More on the proposed desecration of Glen Etive

The Allt Mheuran scheme

The revised Allt Fhaolain proposals

A new access track (in area outlined in red) will connect the existing forest track with the intake

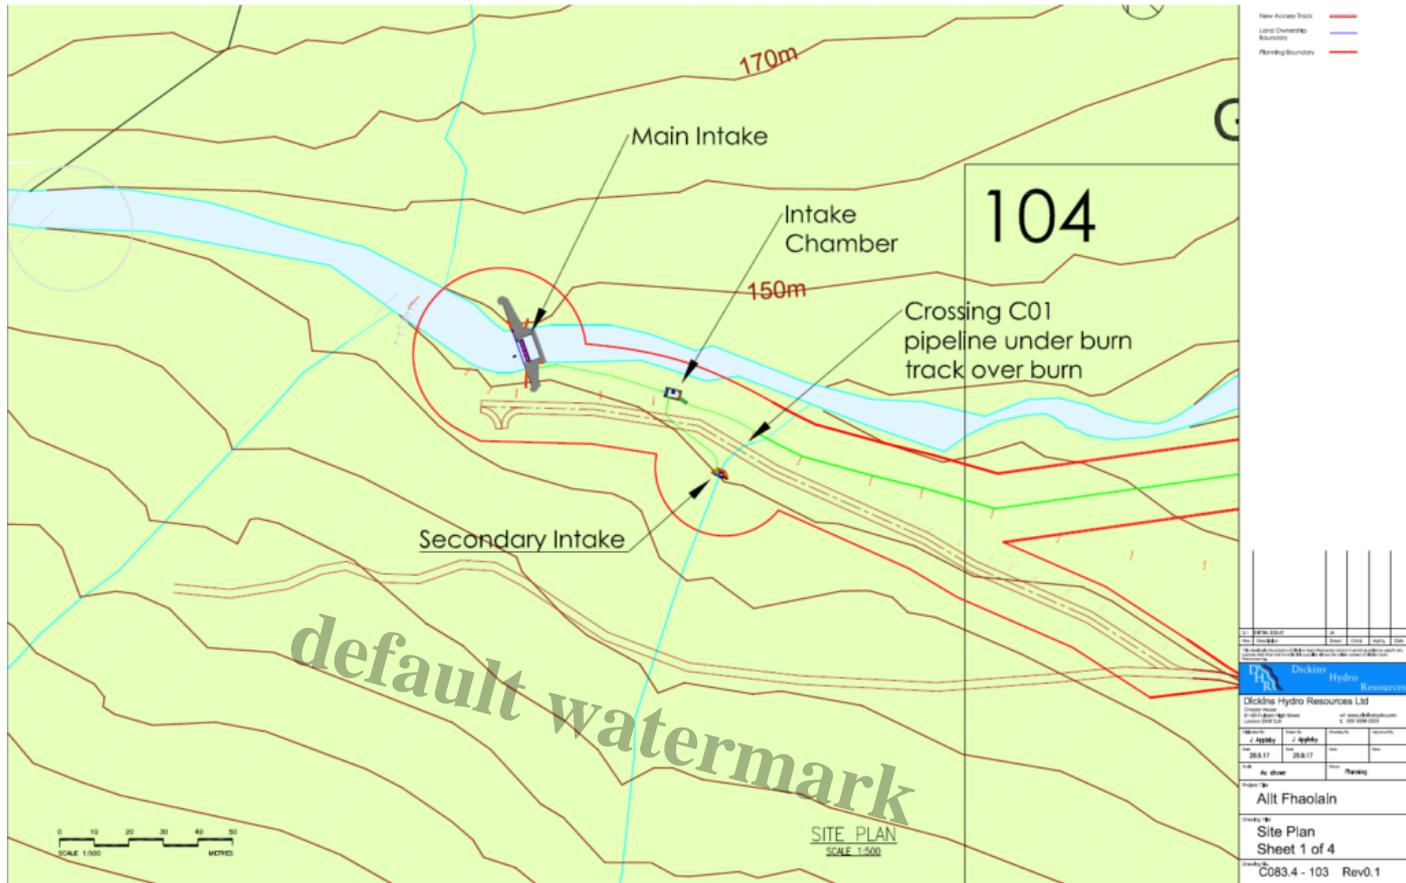
The existing track is to be upgraded, including the replacement of any culverts that require it with bottomless culverts. A new access track is to be created from the existing forestry road to the intake. This will be reinstated at the end of construction to an ATV track. Its not clear what the proposals to upgrade the existing forest track mean. Will it end up wider than at present? The phrasing of the application suggests it won't be narrowed to ATV width. And why does the new ATV track need to be retained? Its only 150m long so turn it into a footpath. It would take 5 minutes for staff to walk it.
